INDIAN HEALTH SERVICE HOSPITAL
BROWNING, MONTANA
FACILITY POST OCCUPANCY EVALUATION

DIVISION OF HEALTH FACILITIES PLANNING
OFFICE OF RESOURCE MANAGEMENT
OFFICE OF MANAGEMENT
OFFICE OF THE ASSISTANT SECRETARY FOR HEALTH

SEPTEMBER, 1990

3. Main entrance, showing sole building identification sign at right of entrance doors.

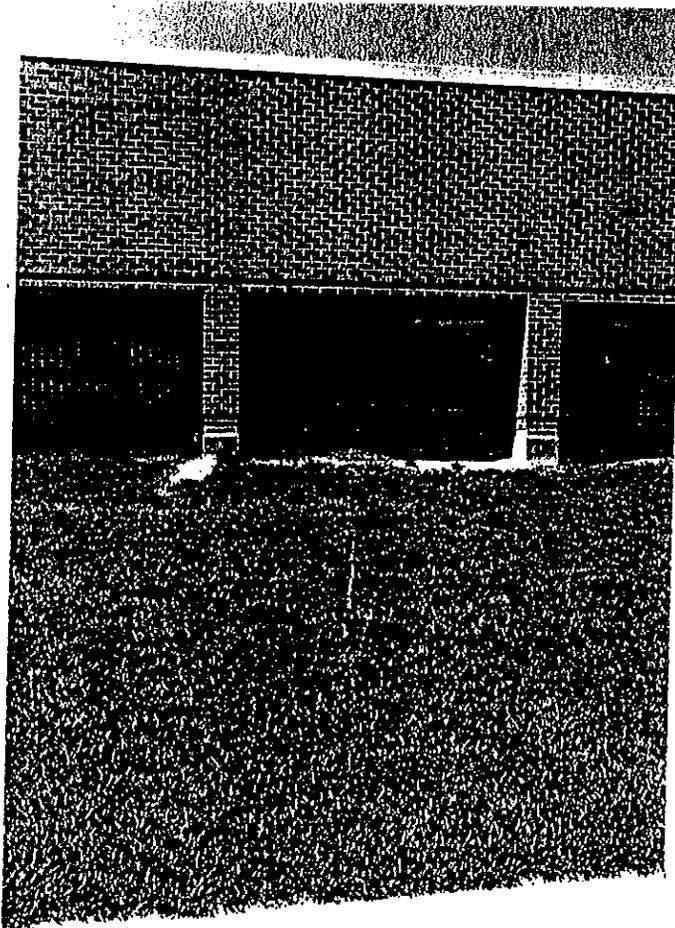
- f. Signage/Identification: The new building is not well identified for the first-time visitor. At the entrance to the BIA/IHS compound, there is one directional sign, which reads "hospital". At the approach to the building there is no sign giving directions to the main entrance, which is actually near the rear of the complex. One could assume that the entrance to the original building, now used for tribal health programs, is the hospital entrance. Once around the east side of the complex and past the fenced vehicle storage area, the only sign, other than parking signage, is mounted on the wall at the front entrance. It reads "Blackfeet Community Hospital." There is no reference to the IHS or PHS (see photo 3).

4. South wall of acute care wing, showing ground bermed up to window sill height. Windows are located in recessed areas under "parapet" wall.

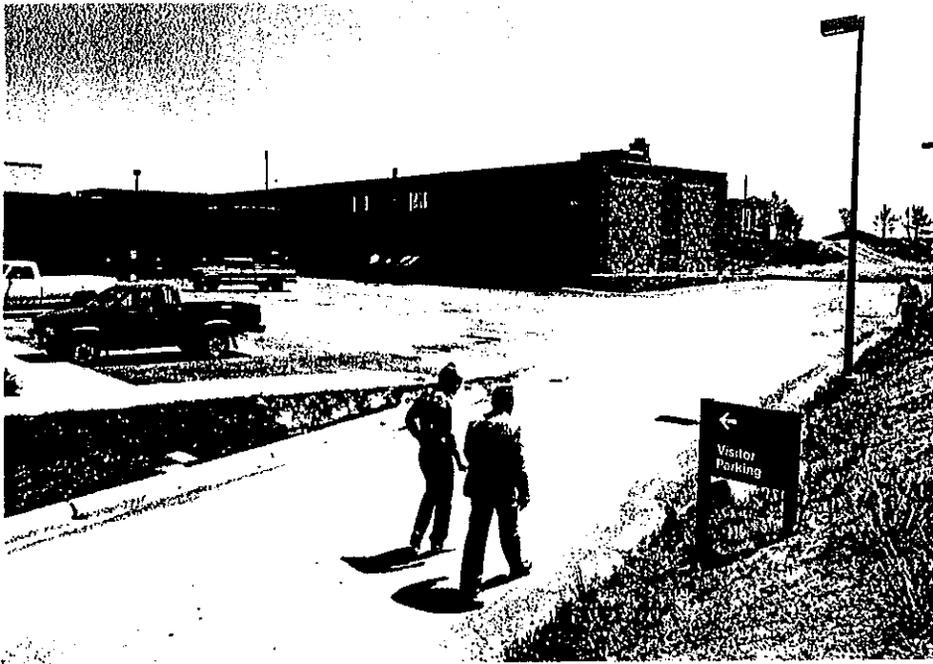
- c. The placement of the Acute Care wing on the west side affords it fine views of the imposing mountain range on the horizon. Since this is also the direction of the prevailing winds, the grade was bermed up to the window sill level (about 3' - 0") on the exterior walls in order to reduce the exposed area (see photos 4 and 40).

25 Hot water heating boiler, dual fueled natural gas and fuel oil. Note lack of pipe hangers over boilers.

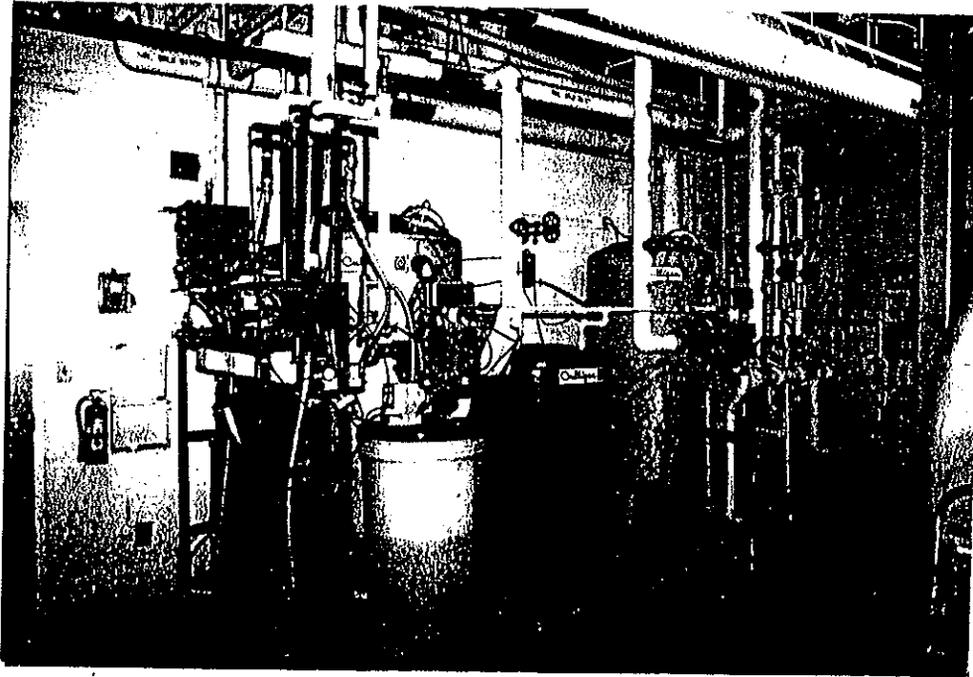
Specification section 15090. There is a lack of pipe hangers. Photo 25, 44, 30, and 35 show where there are:

1. Insufficient hangers
2. Pipes supported on equipment connections
3. No hanger supports within 1 ft. of each elbow

40 Post indicator valve (PIV) note facing of adjacent hydrant and lack of wrench on PIV.

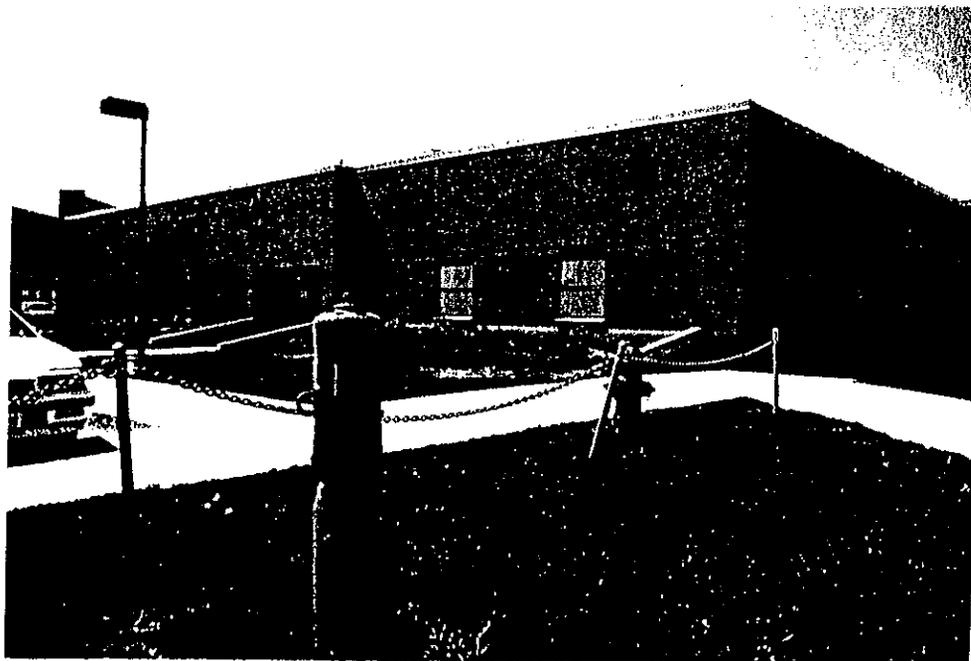
Notice that the handle to operate the post indicator valve is missing (see photo 40). Photo 41 shows the fire department connection is not a siamese. Photo 37 shows the closest fire hydrant (at left in middle of picture) to the hose connection location (right wall in corner of building). NFPA 13, Section 2.7.2, requires the fire department connection to be siamese if the supply pipe is 4 inch nominal diameter, which it is, according to the plans.
